**MEMORANDUM**

**TO:** Historic Preservation Board  
**FROM:** Trisha Logan, Planner III, City of Fort Lauderdale  
**SUBJECT:** 927 SW 2<sup>nd</sup> Court  
**DATE:** April 3, 2017

<b>Case</b>	H17002	<b>FMSF#</b>	
<b>Owner</b>	N.J. Thompson, Inc.		
<b>Applicant</b>	<b>Nancy Cortez</b>		
<b>Address</b>	927 SW 2 <sup>nd</sup> Court		
<b>General Location</b>	Approximately 70 feet east of the SW 2 Court and SW 10 Avenue intersection (north side).		
<b>Legal Description</b>	WAVERLY PLACE 2-19 D LOT 13, 14 & E 5 OF LOT 15 & 5 ½ VAC ALLEY		
<b>Existing Use</b>	Single-Family Residential		
<b>Proposed Use</b>	Multi-Family Residential		
<b>Zoning</b>	RML-25		
<b>Applicable ULDR Sections</b>	47-24.11.C.3.c.i, 47-24.11.C.4.c, 47-17.7.B, 47-24.11.C.3.c.iii		
<b>Request(s)</b>	<ol style="list-style-type: none"><li>1. Certificate of Appropriateness for Demolition<ul style="list-style-type: none"><li>- Demolition of an existing single-family residence.</li></ul></li><li>2. Certificate of Appropriateness for New Construction &gt; 2000 SF GFA<ul style="list-style-type: none"><li>- New Construction of a new two-story duplex.</li></ul></li></ol>

Front Elevation of Proposed New Construction Project

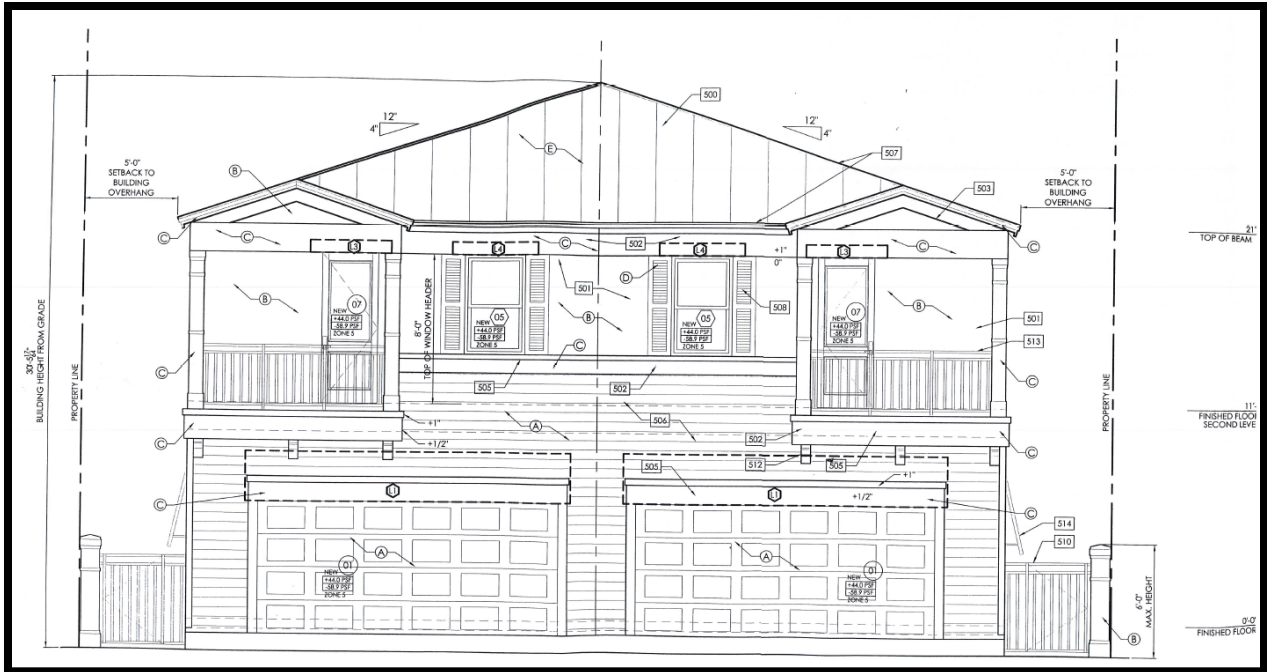
The applicant is requesting a Certificate of Appropriateness for new construction of a new two-story duplex. Overall the new structure is a rectangular floor plan, rising to two stories, with a metal gable roof. Materials on the exterior include wood, metal, and stucco. The front façade of the proposed new construction project contains two two-car garages on the first level, creating two 16'-0" wide driveways with an approximately 4'-0" wide grass median between. On either side of the structure there are metal picket entry gates, tied into a 6'-0" high masonry piers, each gate leads to a recessed front entrance located on the side elevation of the building. Above on the second floor there are two projecting balconies on each corner with two single-hung windows that are symmetrically placed from the center line of the structure, and are framed with inoperable wood shutters.

Within the Sailboat Bend Historic District, it is evident that most historic residences did not have garages that were incorporated in the primary façade of a structure. Majority of the houses had a separate structure that was set to the rear of the lot that would serve as automobile storage. When designing new construction to fit in with the context of the surrounding district, this is an important element to consider since the addition of wide driveways and imposing garage doors will interrupt the rhythm that currently exists along the street. The proposed width of each garage door also exceeds the allowable width per the new construction historic preservation guidelines.

Additionally, locations of fenestration and overall massing do not fit in with the context of the neighborhood. Regarding the fenestration, the entrance of historic residential structures are typically found on the front facade rather than on the side. One of the main rules in designing for a new construction project in a historic district is to imitate the façade proportions and rhythm in placement fenestration throughout the façade. On the proposed new design, there are a variety of window sizes and types placed on the exterior of the structure with ten different size variations present, creating visual clutter on the exterior elevations. Overall massing is one continuous rectangular box without much division in height or width to aid in breaking up the building mass that will be imposed on the neighboring one-story structures.

Height of the proposed new construction project rises to 30'-6" to the top of the roof ridge and allows for a 25'-0" setback in the front, 5'-0" side setbacks, and a 10'-0" rear setback. The front setback should be aligned with the neighboring structures. It appears that the neighboring structures are at approximately 20'-0" each, while the proposed project is at 25'-0". The UDLR requires a minimum front setback of 25'-0", however when a structure is located in the Sailboat Bend Historic District – the front setback may be reduced to up to 15'-0" in order to allow for compatibility with the abutting properties. In this case, the applicant must verify the setback of the neighboring structures and align the new construction project accordingly.

1. The overall width of each garage door is 16'-0" which exceeds the 9'-0" maximum width.
2. Although the applicant is providing operable Bahamian wood shutters in some locations, there are inoperable wood shutters on second floor of the front façade where the size does not match the size of the opening.
3. Sizes and placement of doors and windows throughout the house is inconsistent with others on the street and throughout the historic district.

1. Break-up the overall massing of the rectangular structure and provide a spatial difference between the new construction project and the neighboring structures;
2. Alter locations and sizes of windows and doors to provide consistency within the context of the street and overall historic district;
3. Adjust front setback to align with neighboring structures;
4. Reduce the size of garage doors and impact of the location on front façade; and,
5. Ensure design compatibility within the Sailboat Bend Historic District and provide justification of material and detail choices.
